## **URGENT Field Safety Notice**

**RE:** Addendum to the Instructions for Use (IFU) for Microstream Advance Intubated CO2 Filter Line, VitaLine Intubated CO2 Filter Line and FilterLine Intubated CO2 Filter Line

8 April 2025

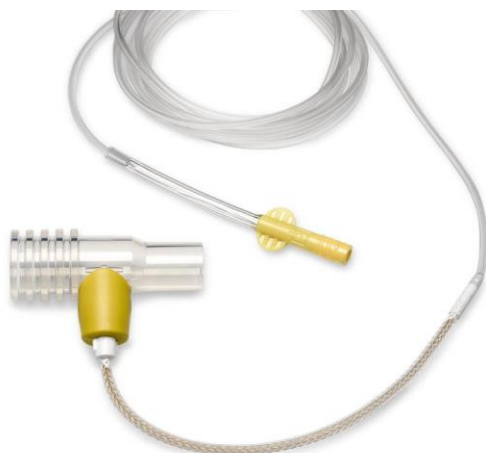
The supplier of the Microstream Advance Intubated CO2 Filter Line, VitaLine Intubated CO2 Filter Line and FilterLine Intubated CO2 Filter Line has provided an update to the Instructions for Use (IFU) for affected product. The IFU addendum is being issued to address customer reports of difficulty or inability to disconnect an adapter from a patient's endotracheal tube in order to perform a procedure. The addendum includes information on potential adverse events that may result from a failure to follow instructions for safe use of the airway adapter, as originally stated in the IFU. Supplier did not identify any anomaly or non-conformance with the product.

The inability to, or difficulty in disconnecting the adapter from the endotracheal tube to perform a procedure such as suctioning or administration of airway medication can result in an unintended extubation to perform the required procedure and/or a delay of treatment.

- Continue using the products following the instructions in IFU. During setup, ensure that the airway adapter can be easily attached and detached from the breathing circuit/tubing before proceeding. The airway adapter can be connected to the breathing circuit/tubing in a variety of configurations. These include a direct connection to the endotracheal tube.
- Pass this notice to all those who need to be aware within your organization or to any organization where affected devices have been potentially transferred.
- Complete the URGENT Field Safety Notice Response Form at the end of this notification to submit both acknowledgment of this URGENT Field Safety Notice and confirm understanding of actions to be taken.

- Following addendum to the IFU will be issued:  
*Adverse events associated with failure to follow the Instructions for Use while attaching and detaching the airway adapter from the breathing circuit are listed in descending order of severity: unintended extubation, respiratory failure, hypoxia, low oxygen saturation, aspiration/inhalation and delay to treatment. Any serious incident related to device use that may occur should be reported immediately to the manufacturer, the local competent authority, and any other regulators as required.*
